CLAREMONT BUSINESS PARK FILING NO. 3

GRADING AND EROSION CONTROL PLAN

El Paso County PCD File No.:
SF-20-014

GRADING & EROSION CONTROL PLAN
CLAREMONT BUSINESS PARK FIL. NO. 3
JOB NO. 44-037
DATE PREPARED: APRIL 28, 2020
DATE REVISED:

SHEET 2 OF 3

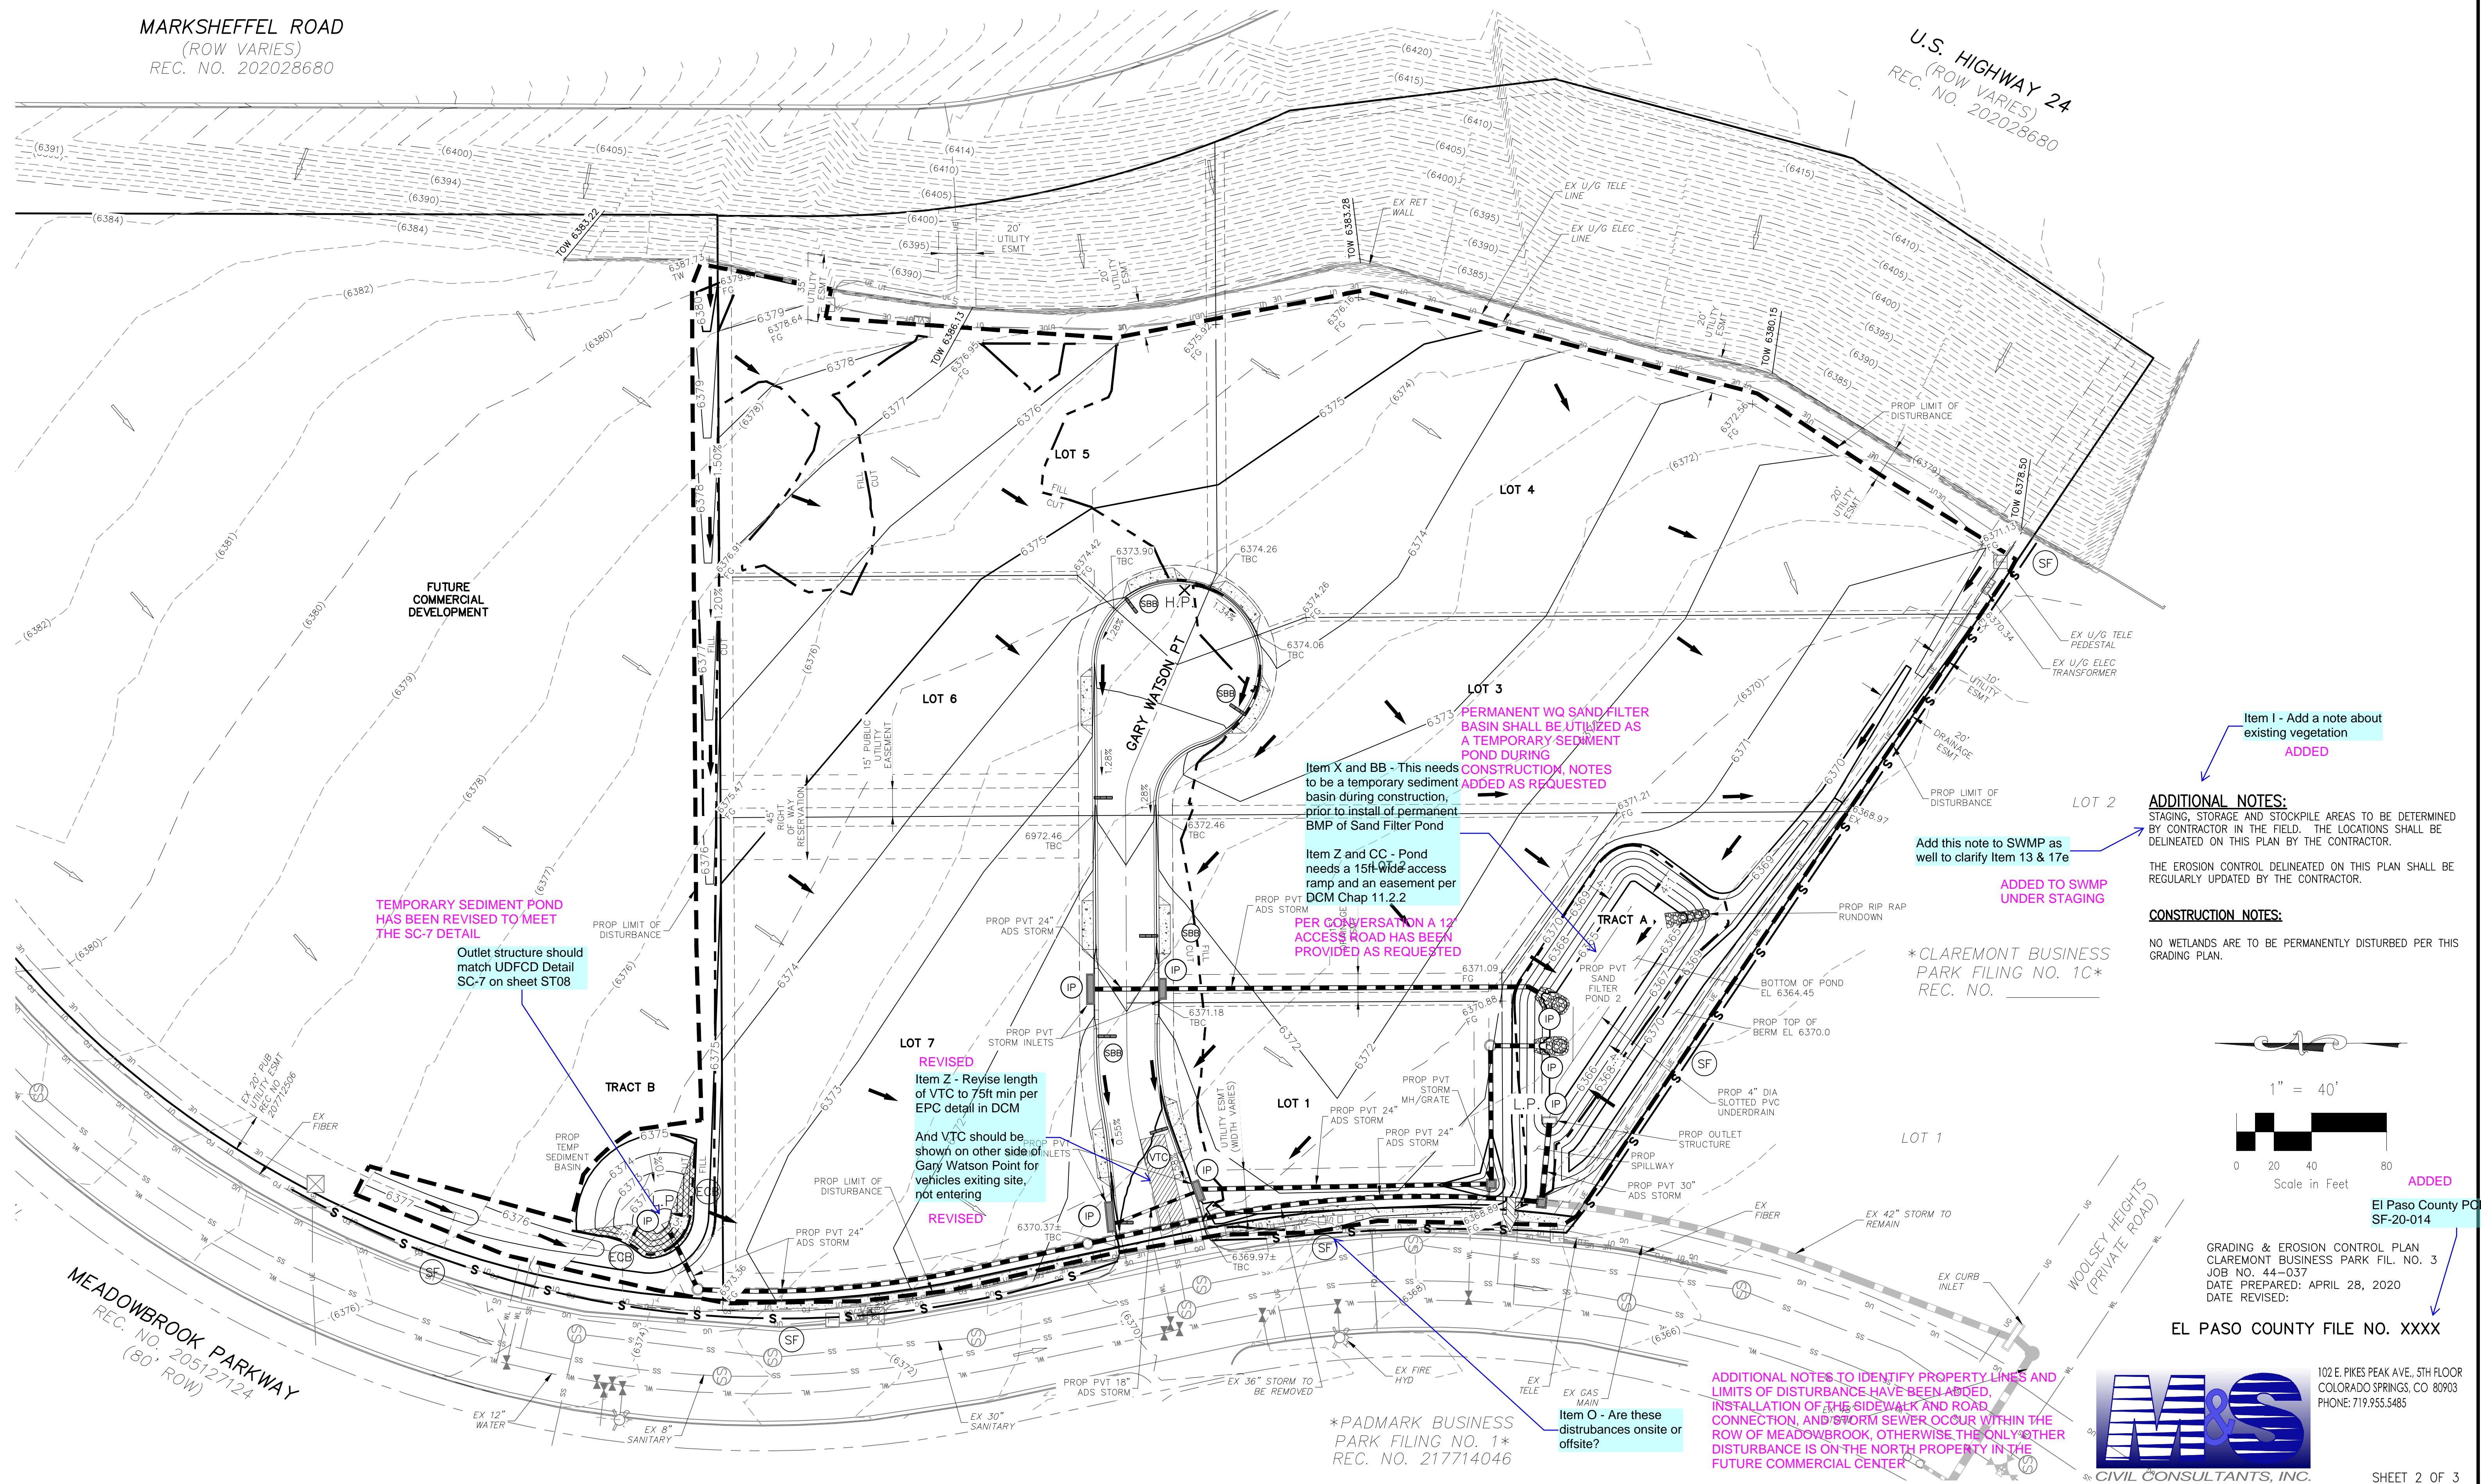
LIMITS OF DISTURBANCE AND PROPERTY LINES ARE DIFFERENT AND ADDED TO THE LEGEND

Item 17a & 17c - if same as Construction Site Boundaries, label as such

ADDED Item E - Show property lines on Legend and Plan

ADDED Item EE - Shown easement linetype on Legend

ADDED Add Concrete Washout to Legend and show proposed location on plans (even though SWMP says that the location will likely change)

ADDED Add Mulching and Seeding to Legend and show on plans

ADDED Add Temporary Stockpile Location to Legend and Plans

Item FF -
Revise to say
"COUNTY"

ADDITIONAL NOTES TO IDENTIFY PROPERTY LINES AND LIMITS OF DISTURBANCE HAVE BEEN ADDED, INSTALLATION OF THE SIDEWALK AND ROAD CONNECTION, AND A FUTURE SEWER OCCUR WITHIN THE ROW OF MEADOWBROOK, OTHERWISE THE ONLY OTHER DISTURBANCE IS ON THE NORTH PROPERTY IN THE FUTURE COMMERCIAL CENTER

GRADING & EROSION CONTROL PLAN DETAILS
CLAREMONT BUSINESS PARK FILING NO. 3
JOB NO. 44-037
DATE PREPARED: APRIL 28, 2020
DATE REVISED:

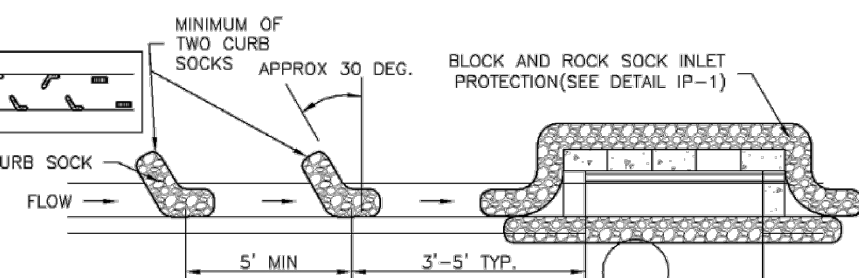
Item 20 & Z - Add details for:
- Straw Bale Checks
